Cumberland Basin bridges scheme

1. Planning and design

2. Construction

FIG. 25

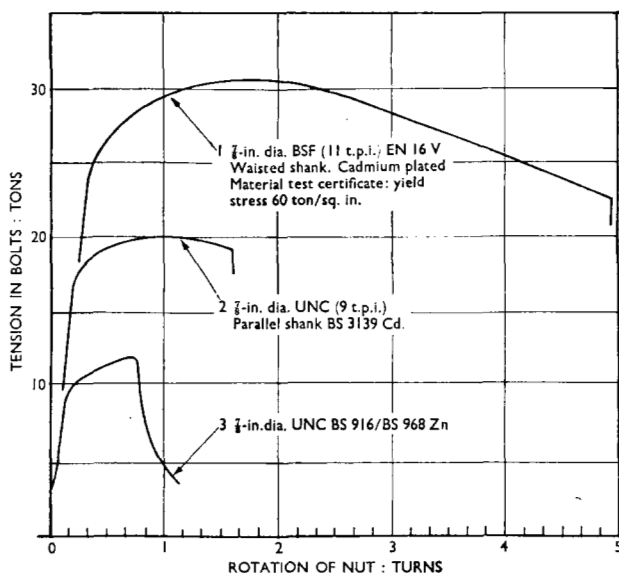
Dr T. A. Wyatt (Imperial College) commented on the difficulties of tightening high strength bolts, referred to in § 181. At Imperial College he had done a number of tests on the tightening of structural bolts, using a test set-up which gave a reasonable simulation of a real joint. The tension in the bolt was indicated by electric resistance strain gauges on the shank of the bolt. Fig. 25 showed some typical results.

263. The first curve referred to $\frac{7}{8}$ in. diameter waisted-shank bolts of EN 16V steel, using a shouldered nut with a special thick washer. The grip length was $2\frac{5}{8}$ in. The tests started from the so-called hand-tight condition, in this example a torque of 130 lb/ft, although the actual torque value chosen for the datum was not critical within the range of from 100 to 400 lb/ft. For a turn of the nut between $\frac{3}{4}$ and $2\frac{1}{4}$, the tension was close to 30 tons: the wide margin was available because the whole shank length stretched.

264. The tests showed that the total extensibility of the bolt ($2\frac{5}{8}$ in. grip) was equivalent to a plain cylindrical bar about $\frac{3}{4}$ in. longer than the grip. For a short bolt, say 1 in. grip, the equivalent total length would thus be $1\frac{1}{4}$ in. On this basis the necessary turn of the nut would be only half of that for the longer bolt, or half a turn

for full tension, leaving about two turns margin on breaking the bolt. He had found this method of correcting for grip length to be generally satisfactory.

265. The second curve referred to the more common pattern of high-strength bolt where a margin of extensibility was obtained by having a substantial threaded length of the bolt within the grip rather than by reducing the diameter of the whole shank. The third curve referred to the conventional structural bolt, using high yield stress steel to B.S. 968.

266. Dr Wyatt felt that this repetition of known facts was justified to emphasize two points. First, that the threads of a modern bolt were expected to do up to three times the work of what had previously been regarded as a high-tensile bolt. Second, that there should still be ample margin. This should be true even when the bolt was rather short: using the shouldered nut and special washer, it had been found possible to tighten bolts when over two turns of the nut were required to bring the bolt flush with the face of the nut, and within this limit it was impossible to strip the thread, provided it was clean and undamaged.

267. If an erector damaged the thread of a black bolt getting it into place, this was perhaps just an added safeguard against subsequent working loose, but a high strength bolt was quite a different matter. Grit and corrosion were two other enemies, and lubricant was a doubtful ally. A molybdenum disulphide lubricant certainly reduced the torque required, but very careful supervision was required to prevent excess, and it increased the danger of picking up grit.

268. Dr Wyatt suggested that there was a big problem in supervision and education of erectors to treat the modern bolts with proper respect: he asked the Authors if they shared this opinion, or whether there had been any particular defect in the bolts used on the swing bridge which had contributed to their problem.

301. In reply to Dr Wyatt's suggestion that the difficulty encountered with the high-strength bolts was due to careless handling by the erectors, the Authors pointed out that trouble had only been encountered when the length of bolts was calculated to ensure that the bolt did not protrude from the nut after tightening, and when no allowance had been made for the increased thickness of plates due to protective coating and rolling tolerance. Under these conditions approximately 3% of the bolts had stripped their threads and a much higher proportion of the bolts had extruded a thin sliver of thread metal during tightening. When the bolts were replaced by longer ones which resulted in the bolt protruding from the nut when tightened, no further occurrences of thread stripping were encountered yet the actual method of tightening and supervision of the tightening was exactly the same.
